**INVITATION TO BID (ITB) FOR
POOL CONSTRUCTION AT THE FORD
WOODS PARK**

**CONTROL No. 122972
ADDENDUM No. 1**

PROJECT: City of Dearborn - Ford Woods Park Pool

ADDENDUM NO.: One

S1.0

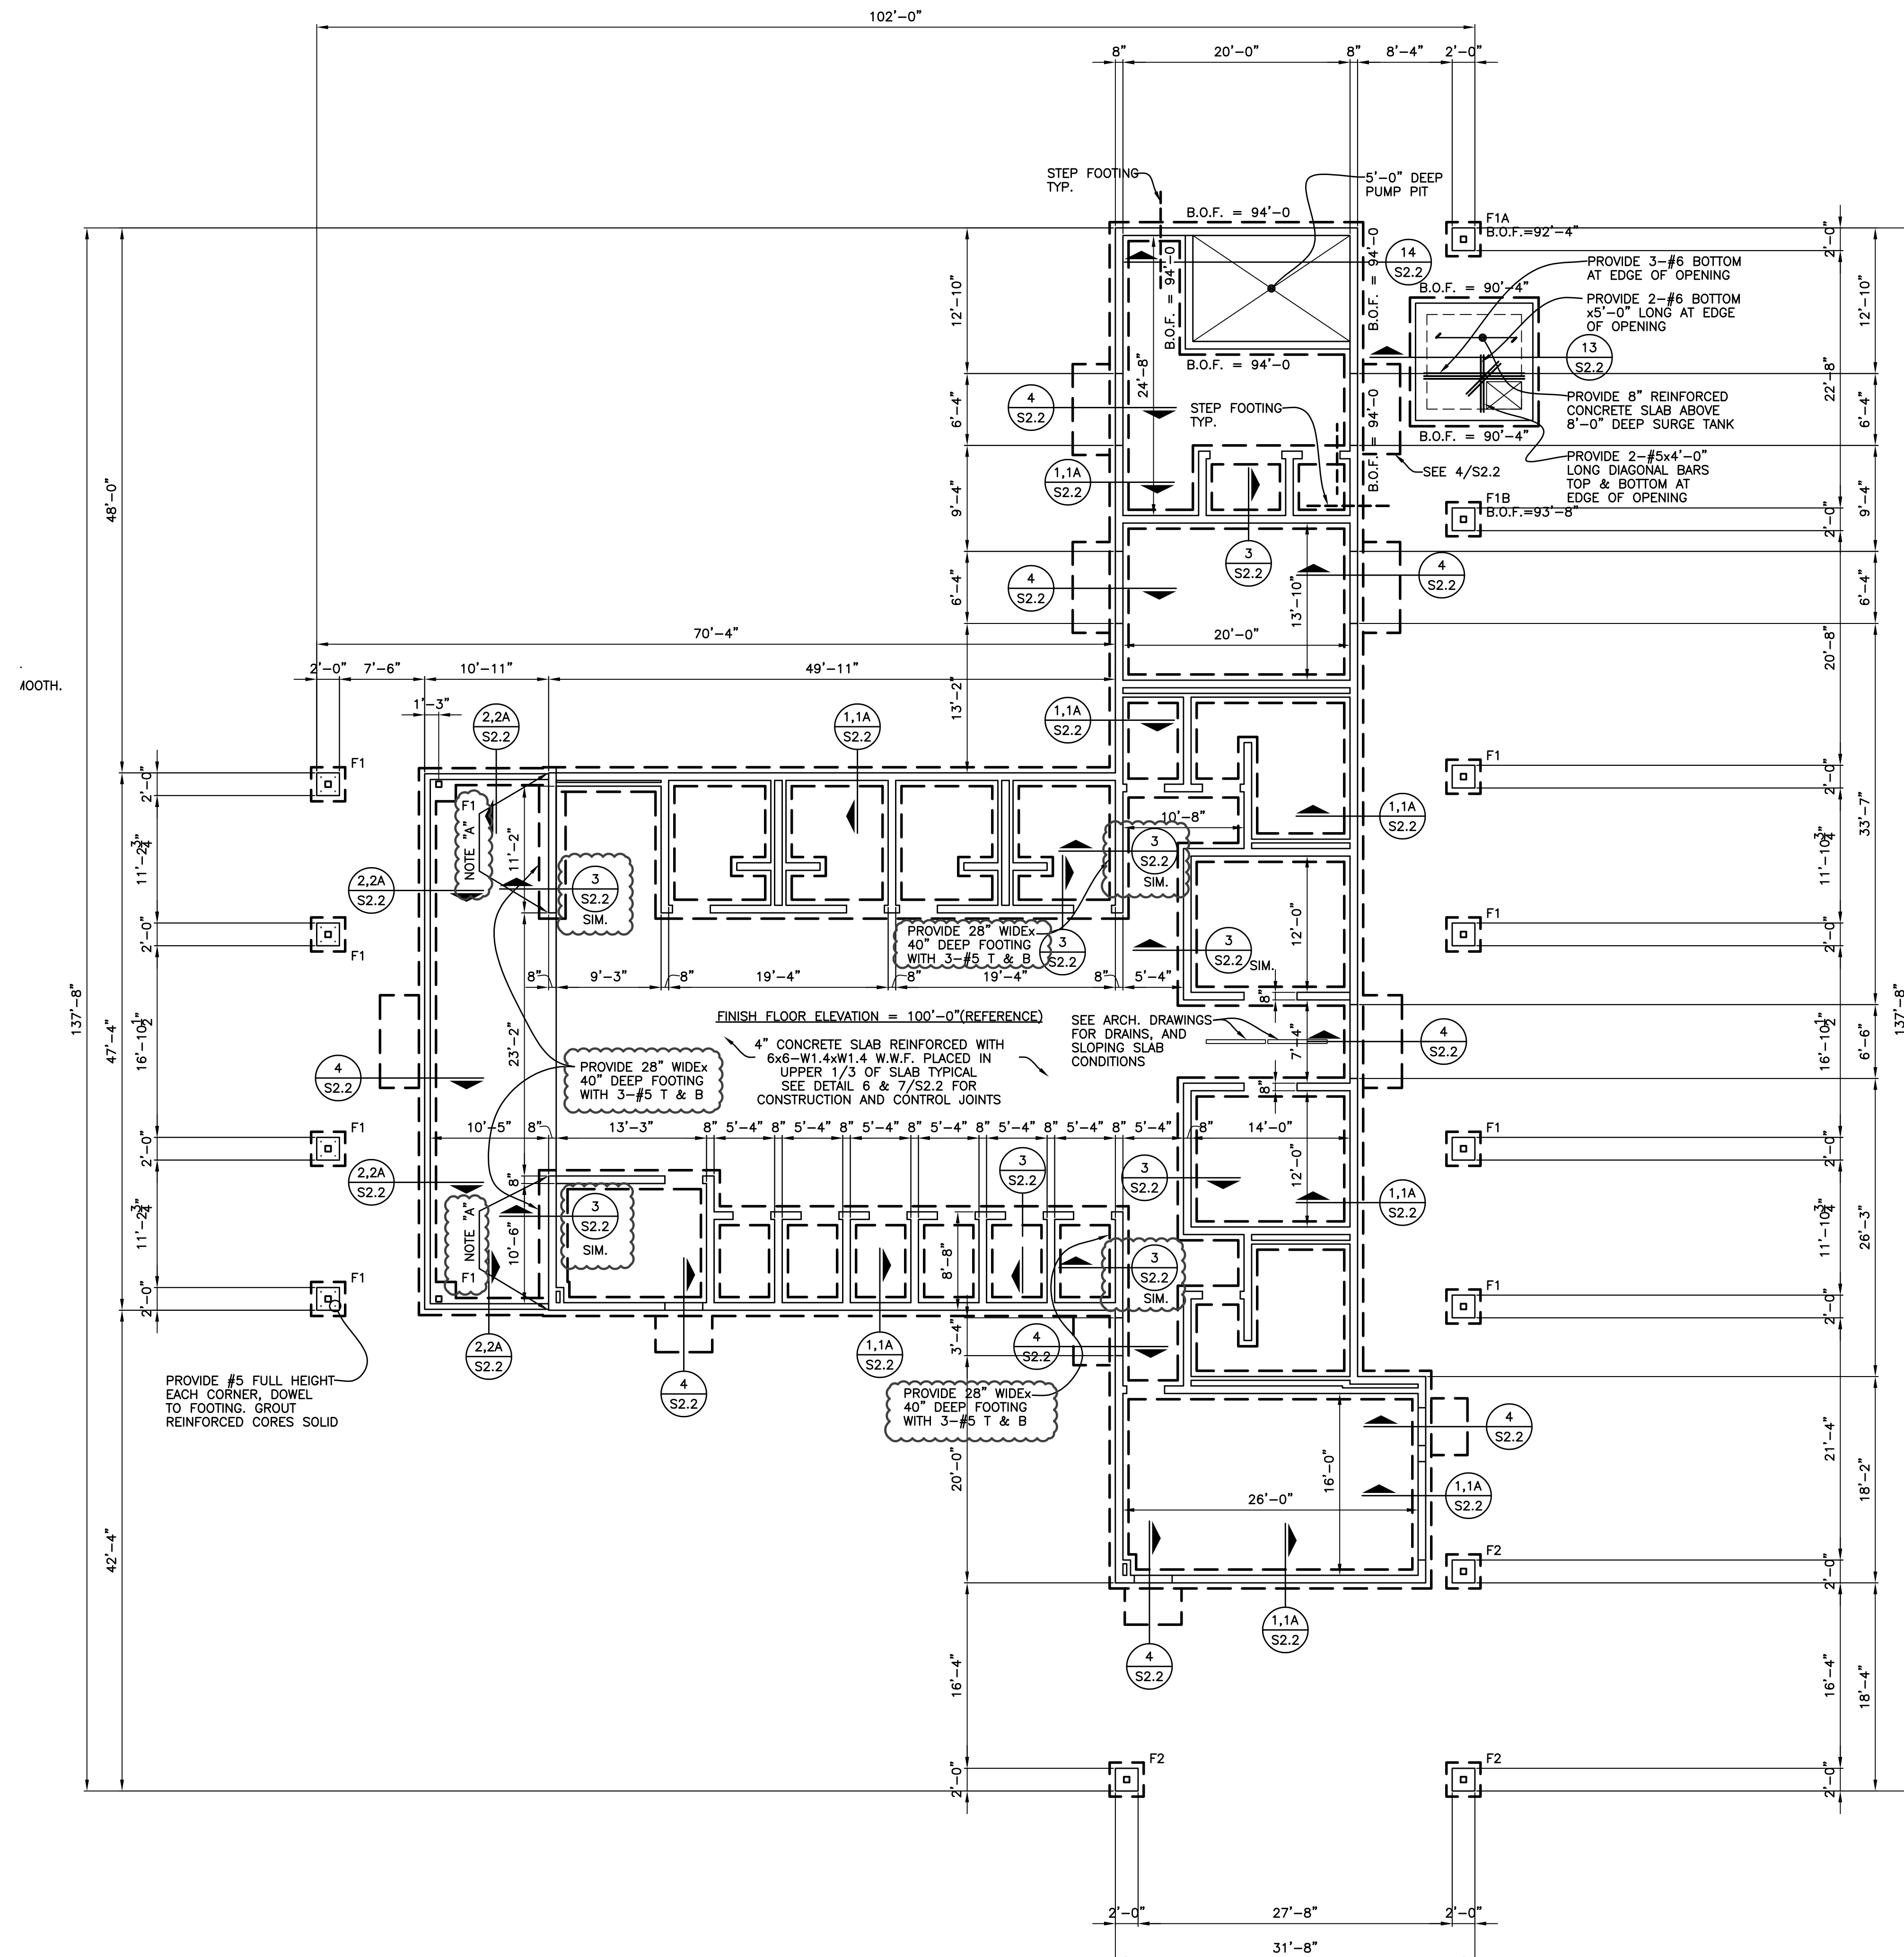
- SD-1 Refer to all Structural Drawings issued for BID (not reissued):
- A. Added Project No. "17071" to all Structural Drawings.
- SD-2 Refer to Drawing No. S1.0 (reissued):
- A. Revised footings at west wall of "Office" 119, west wall of "Vending" 100, east wall of "Toilet" 104, and east wall of "Changing Room" 113 to be 28" wide x 40" deep with 3-#5 top and bottom.
 - B. Added note "A" on drawing, and on plan.
 - C. Added F3 footings.
 - D. Added 3/S2.2 SIM. Detail cuts.
- SD-3 Refer to Drawing No. S1.1 (reissued):
- A. Added details 1, 2, & 3 and indicated them on the roof framing plan.
 - B. Added notes at "Break Room/First Aid" 112.
 - C. Added shear wall sw-1 locations.
 - D. Added T1* locations and note.
 - E. Added horizontal and diagonal wall bracing.
 - F. Added glulam bridging at truss bottom chord.

8 SECTION
S3.0 SCALE : 3/4" = 1'-0"

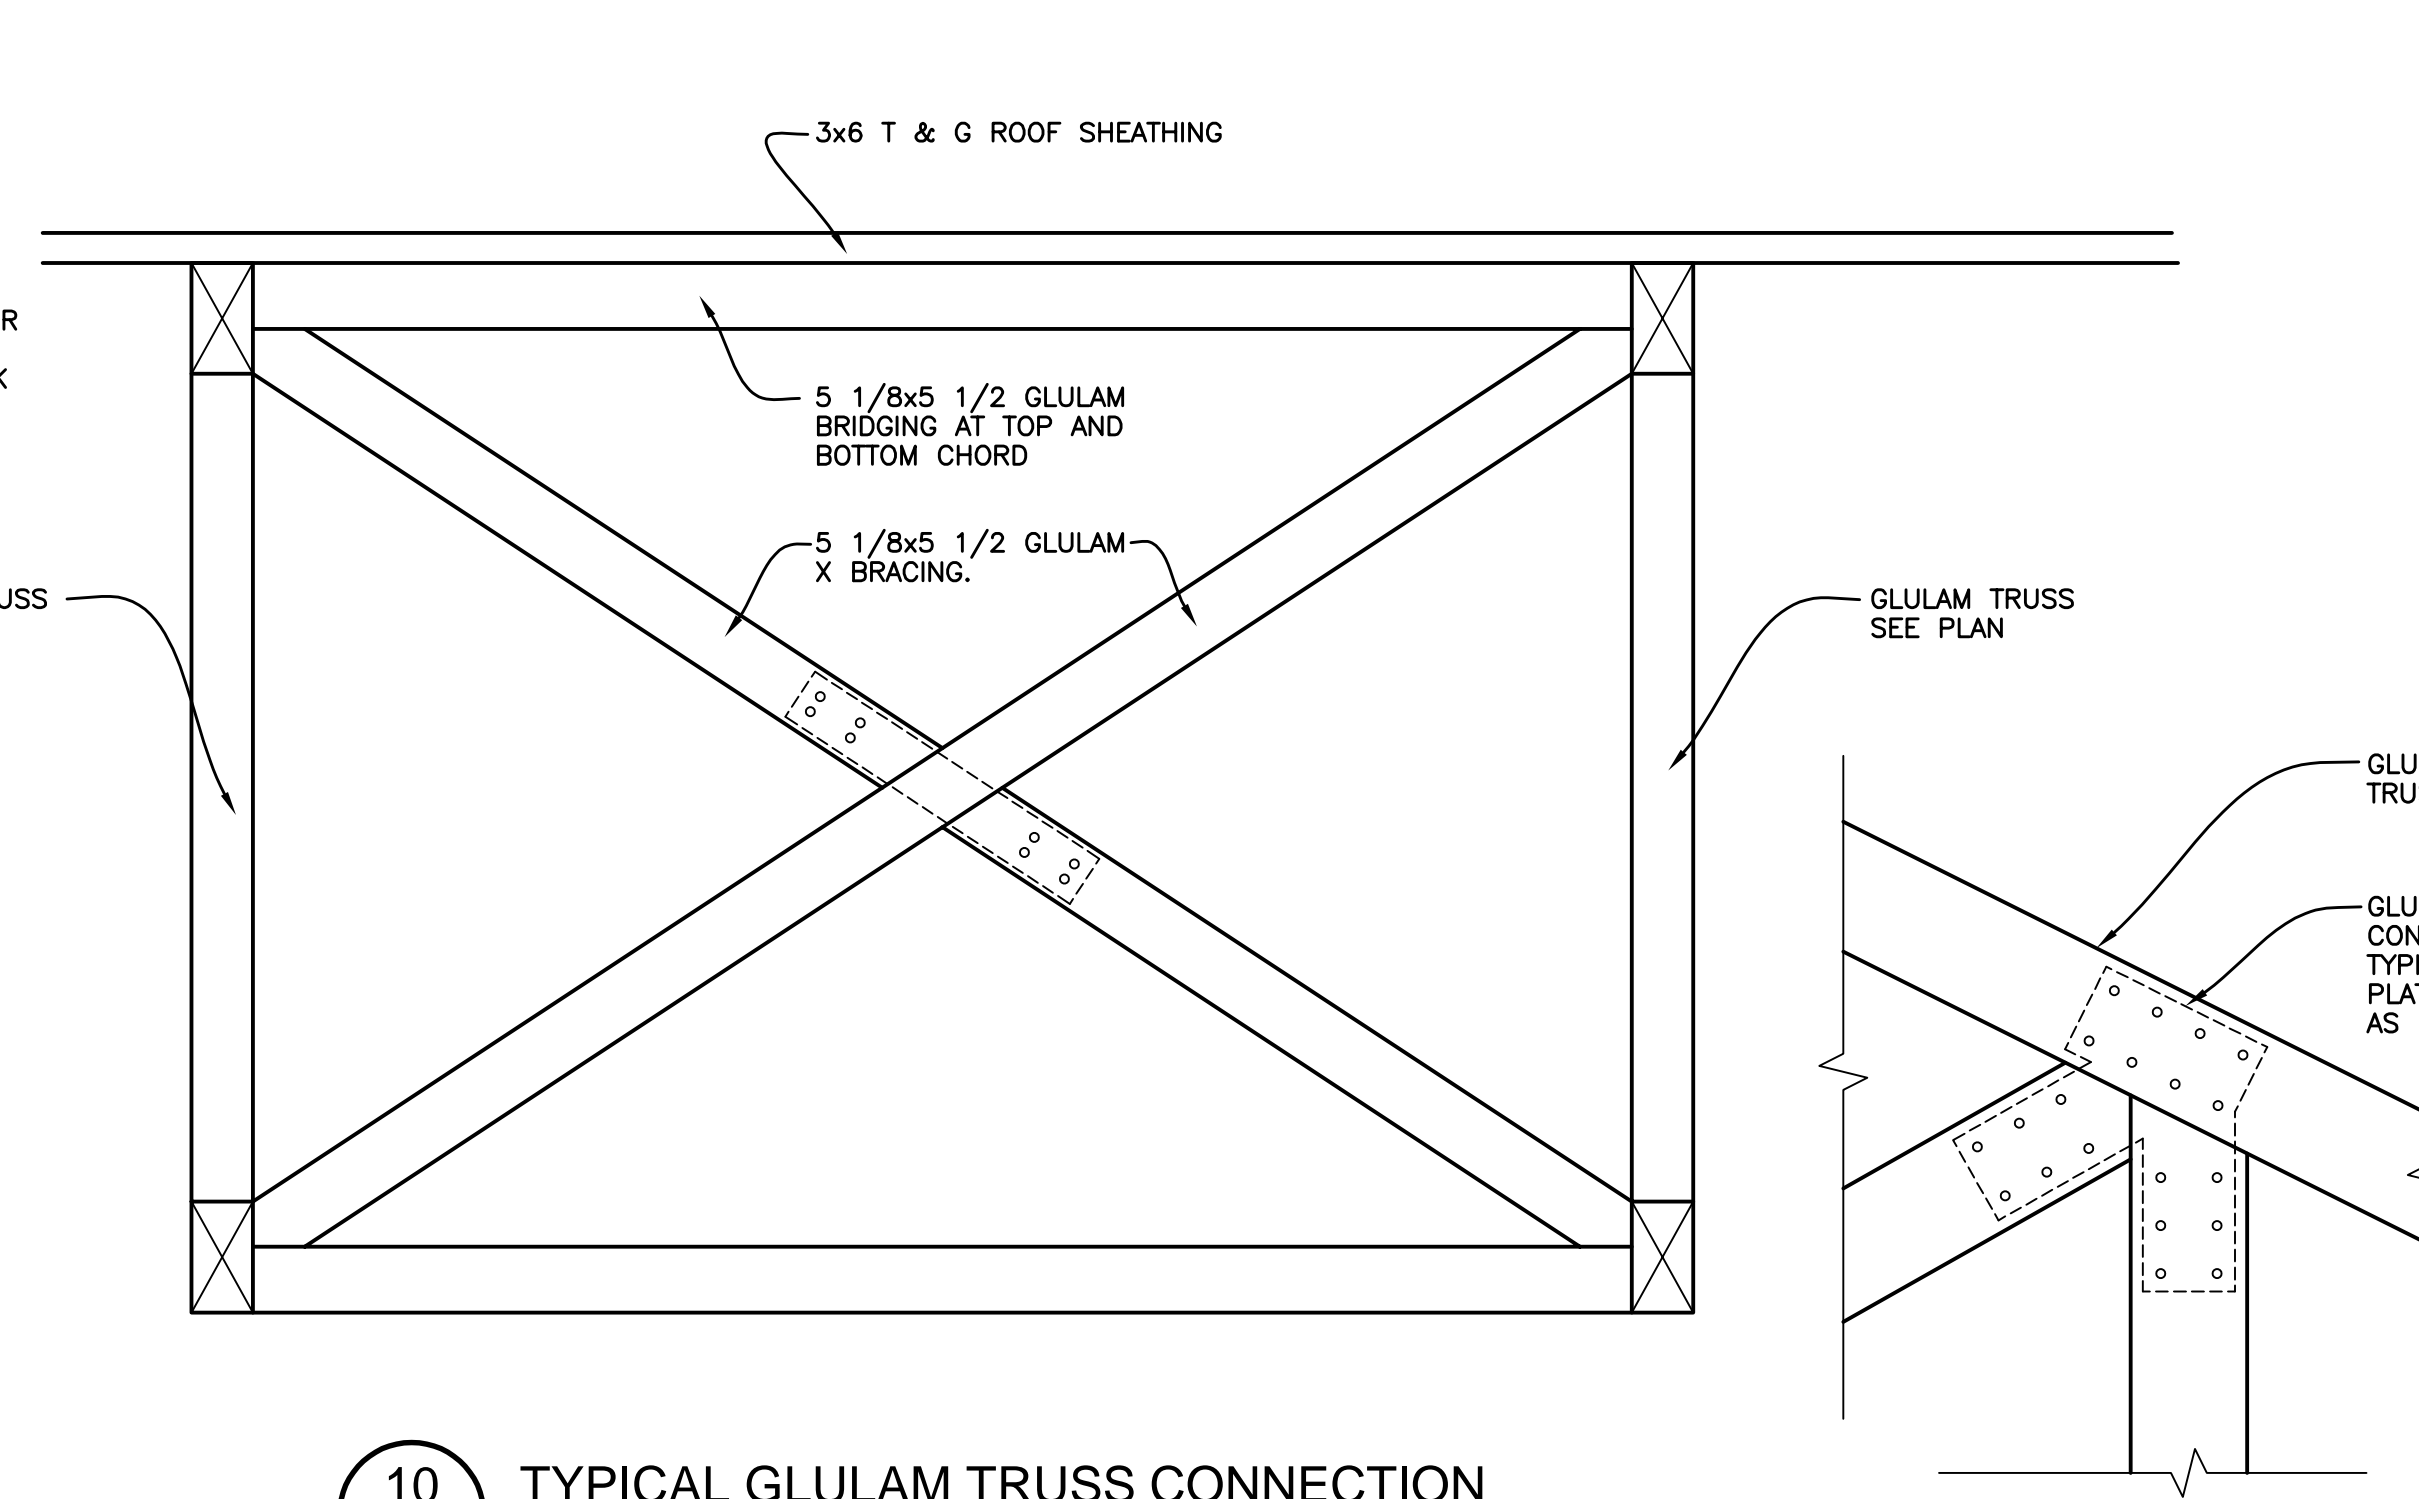
- SD-4 Refer to Drawing No. S3.0 (reissued):
 - A. Revised details 4 and 8 as indicated.
